Architect's Field Report

15094 Community Bank Headquarters / Report Number 032

Observations For 219048 - Community Bank

#196: Counter flashing

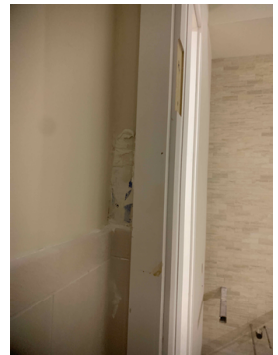
Assignee: Description:
This is actually outside on the balcony; flashing has been very poorly caulked And Seal is not continuous

#182: Room is too large

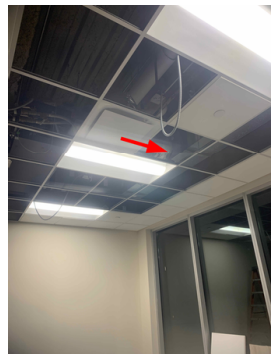
Type: **Quality > Corrective Action**
Location: **Interior>Level 3>3402 Marketing**
Trade:
Status: **Ready For Review**
Date Notified:
Priority: **High**
Due Date: **2021-12-14**
Spec Section:
Assignee:
Description:
Created By: **Paul Purser**
This room is 2 feet wider than it should be

#177: Leak at façade

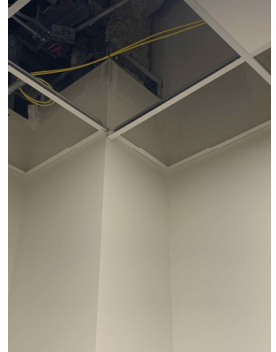
Created By: **Water is entering façade**
Paul Purser

#175: Where is our nook?

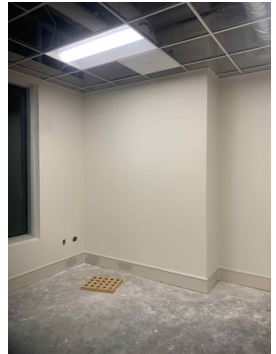
Type: **Quality > Corrective Action** Location: **Interior>Level 3>3204 Credit Director**
Trade: Status: **Closed**
Date Notified: Priority:
Due Date: **2021-12-09** Spec Section:
Assignee: Description: **Plans indicate a nook here**
Created By: **Paul Purser**

#173: Are these flat panel lights correct?

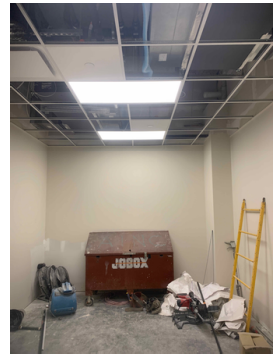
Description:
Are these the correct lights?

#172: Missing door?

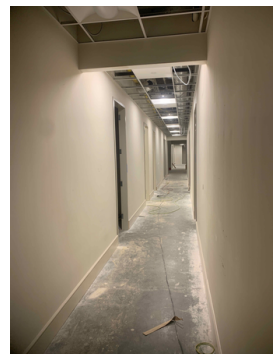
Description:
Are we missing a door here?

#170: Move supply register closer to window

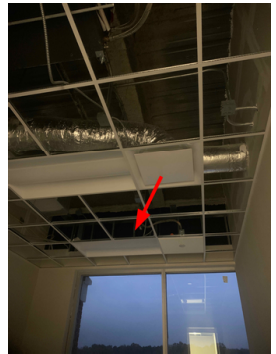
Move register as indicated

#164: Bank Teller Window Flashing

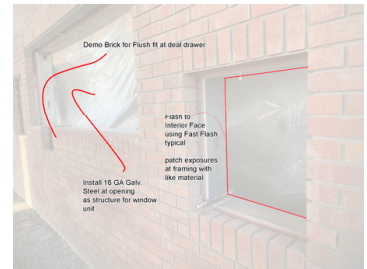
Per our on site meeting last week, details for flashing the teller window are as follows:

Fast flash will be employed to flash each opening to the interior wall plane and unit shall be sealed with mastic at that location. Flashing shall be applied at all jambs, sills, headers, and corners throughout. Openings in metal framing shall be covered with like material.

At the shelf created by the new metal stud wall below the precast panel, fast flash shall be applied to brick surface, horizontal shelf, & down face of gypsum substrate.

At the main window, galvanized steel shall be employed continuously around opening so that window unit can be brought out flush with brick face. Where this unit meets the deal drawer, the steel may be notched as needed to fit drawer. The deal drawer shall be flush with both the window unit as well as the brick face.

#161: Lobby furr down heights

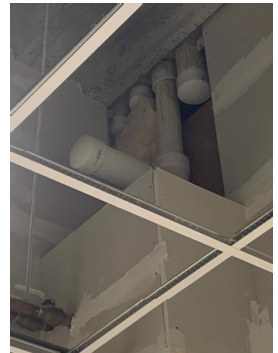
Description:
Due to the change in height of door 4001a, The furr down opposite this door in the elevator lobby should match in height; Issues concerning tile joints shall also be considered so that they line up with this new furr down height.
